ADDENDUM NO. 02

PROJECT: **Window and Door Replacement at Cary High School**
Wake County Public School System
WCPSS Project Number: 862-0710/368
Atlas Engineering Job No. J2443

CARD READER
RENOVATIONS

01 CARD READER RENOVATIONS
E100 1/16" = 1'-0"

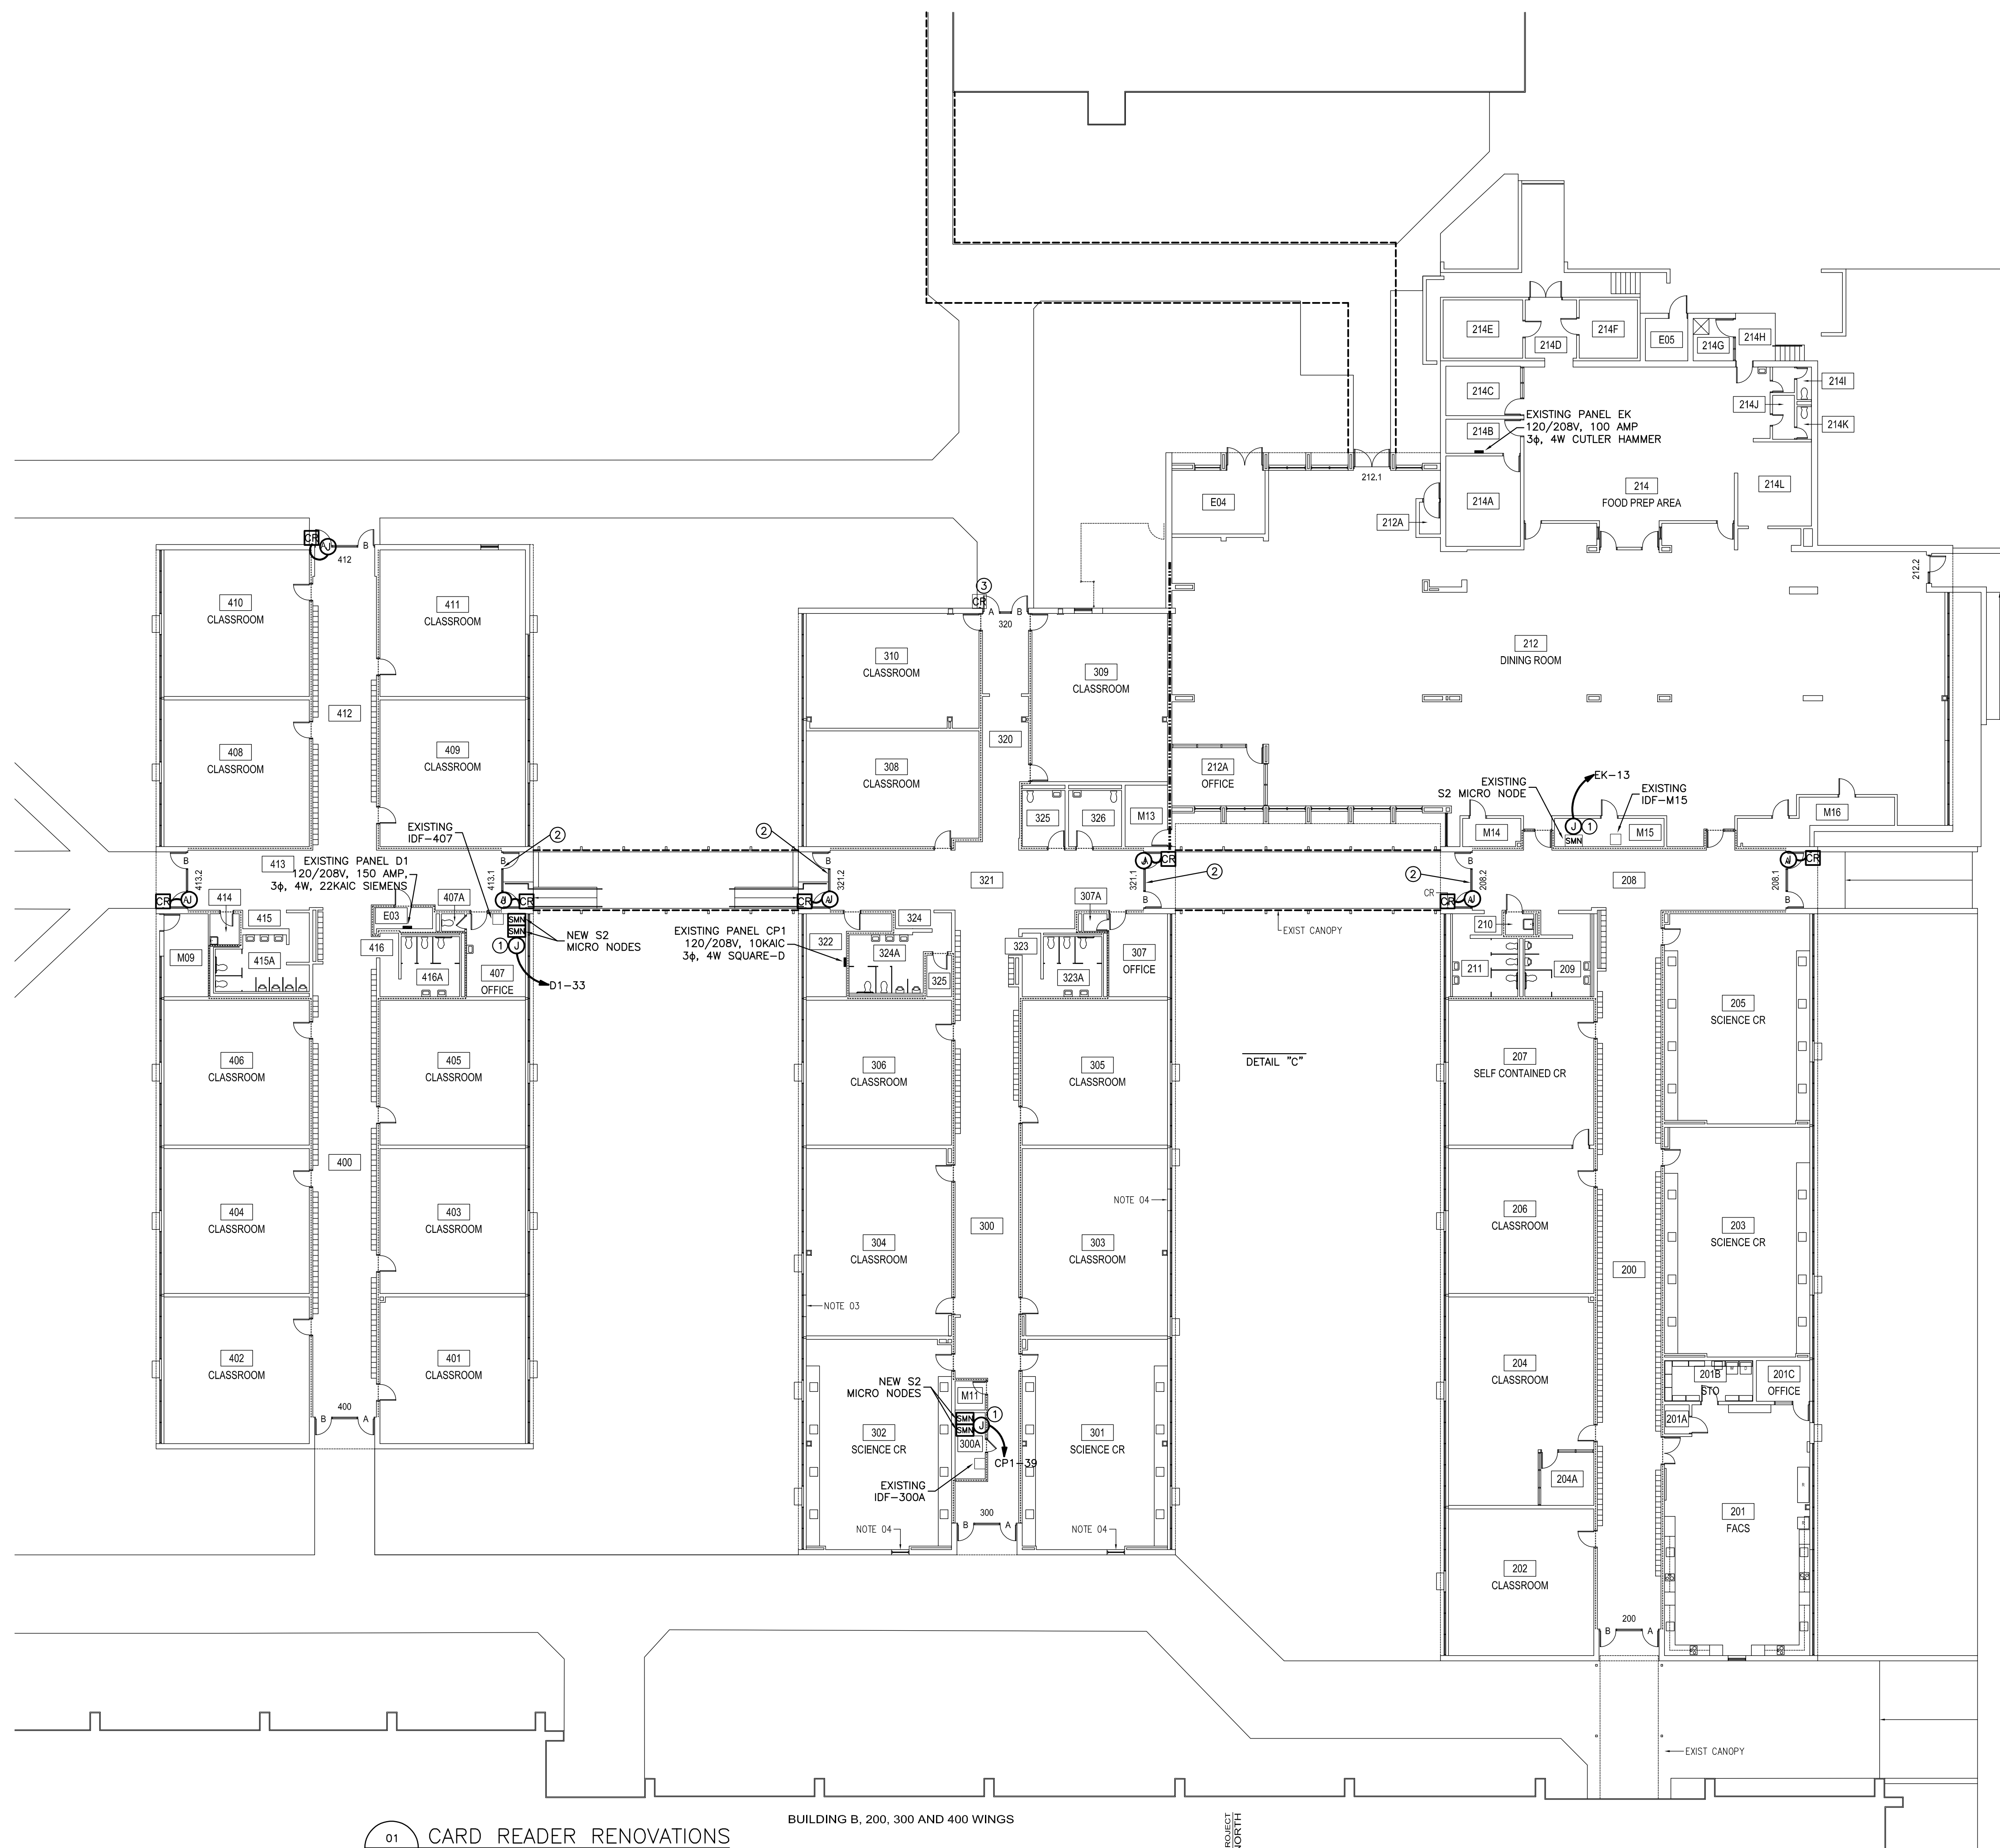
The attached E100 CARD READER RENOVATIONS (dated 28 October 2021) replaces the original E100 found in the drawing package. This new E100 corrects several inconsistencies between the electrical layout and architectural layout and clarifies the location of several card readers and associated equipment. No other changes were made to this revised E100 sheet.
